**ROCKFORD BOARD OF EDUCATION
INVITATION FOR BID ON SUPPLIES, MATERIALS, EQUIPMENT OR SERVICES
FOR SCHOOL DISTRICT NO. 205
ROCKFORD, ILLINOIS**

IFB No. 22-23 HVAC & Roofing Projects at Lincoln, East, Washington & Flinn Schools

RE: **ADDENDUM NO. 9**

4 B TYPICAL DETAIL AT ACCESS DOOR B

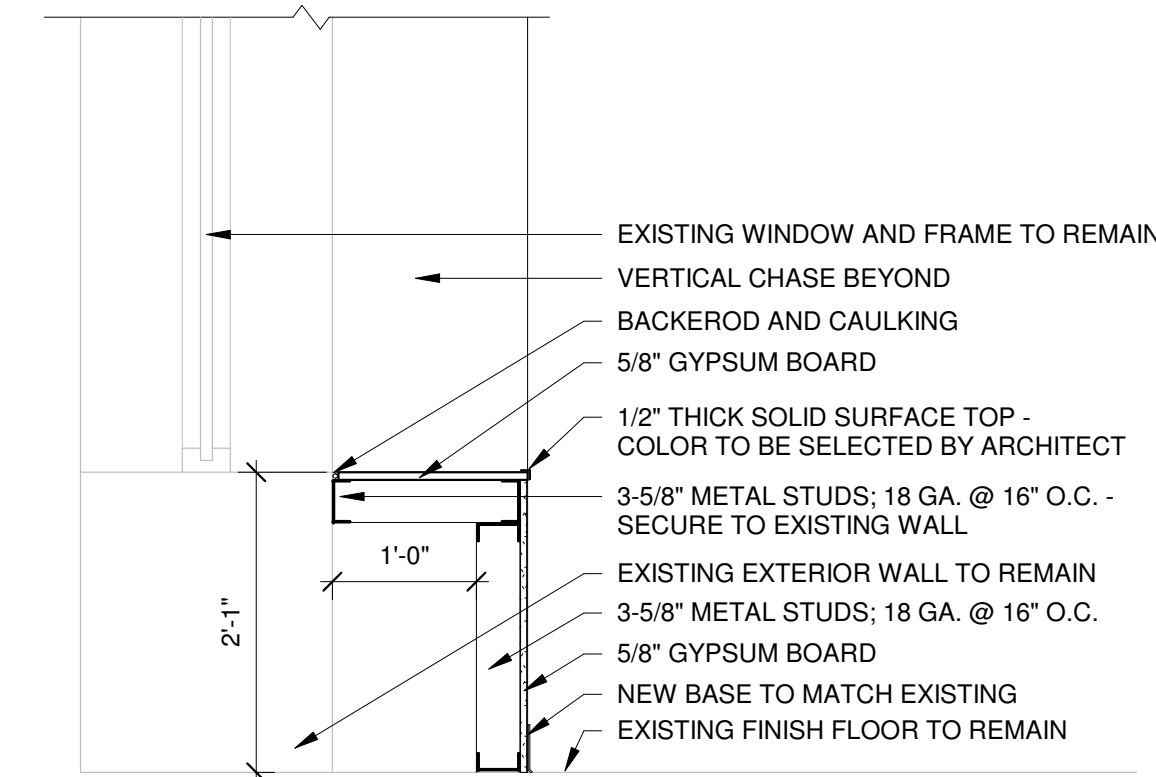
- b. **ADD** detail "4B/A4.00".
- 29. DRAWING E102B - SECOND FLOOR DEMOLITION - ELECTRICAL - AREA B & C
 - a. **ADD** existing fixtures and Keynote #1 to Area B.

E102D

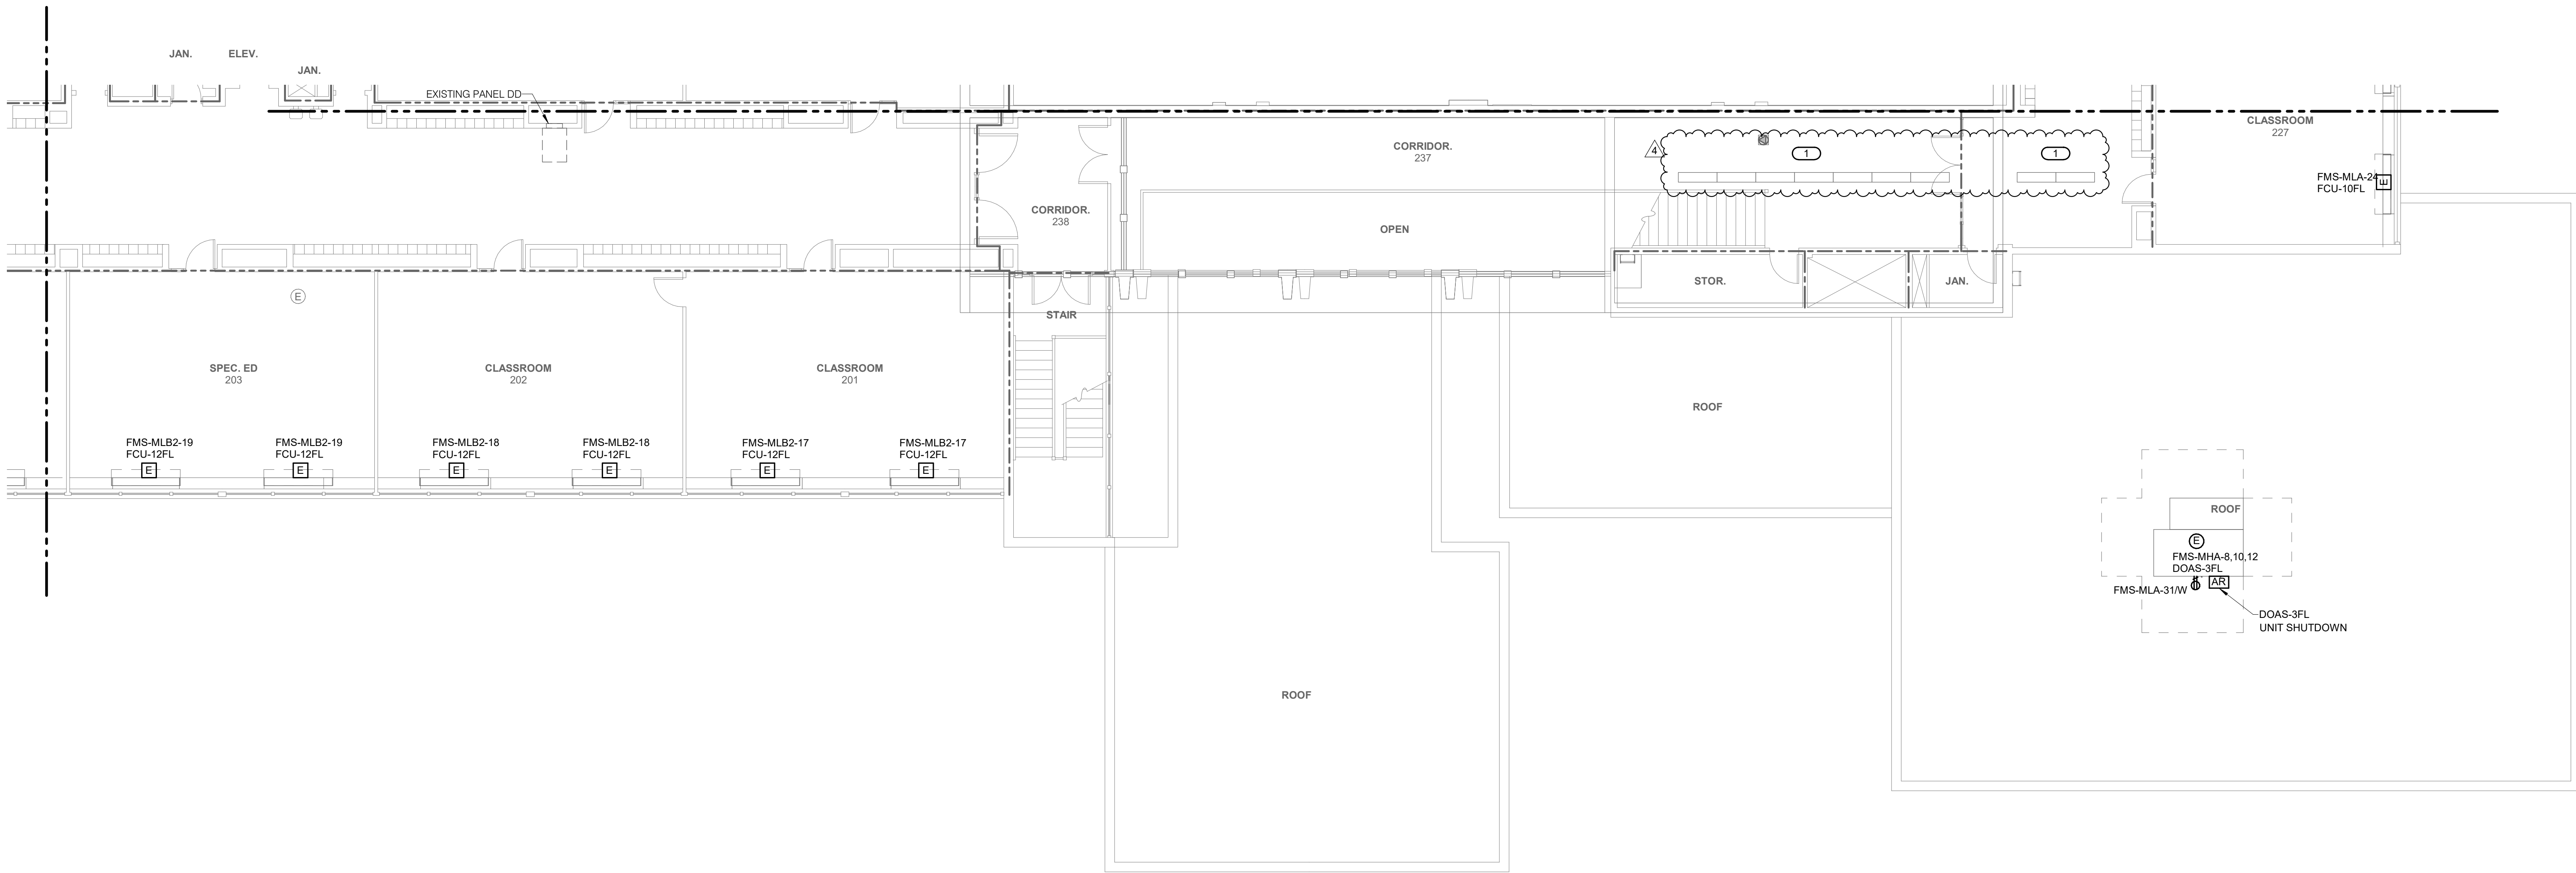
- b. **ADD** Keynote #1 to sheet.
- 30. DRAWING E102D - SECOND FLOOR DEMOLITION - ELECTRICAL - AREA D
 - a. **ADD** Keynote #2 to upper stage. Refer to revised drawing E102D.
